SKILLING - [illegible] - CONNECTION

PROJECT THE [illegible] CENTER — FLOOR TRUSS CONNECTION DETAIL — 5/14/69

Section a-a

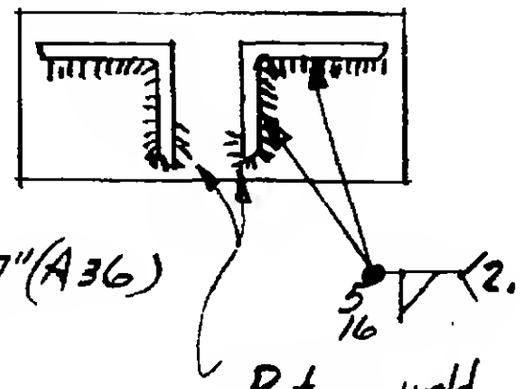
Add 2-#5 Cont.
